I. Software Guidelines

II. Corrections To The Manual

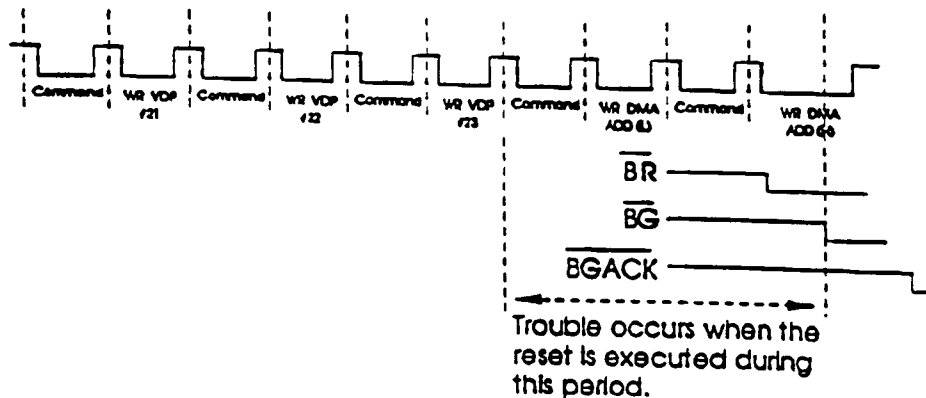
3. Repeated Resets

- 1) The software goes out of control when resets are repeated.

Diagnosis Of The Problem:

- When the reset occurs, the CPU is reset; however, the VDP is not reset.
- When the reset occurs during DMA, the VDP continues the DMA.
- The VDP is accessed right after the reset. If this is done while the VDP is executing a DMA, then this access becomes ineffective.

A Fix For The Problem:

Before accessing the VDP after the initialization program (ICD_BLK4), check the DMA BUSY status register. If a DMA is being executed, do not attempt to access.
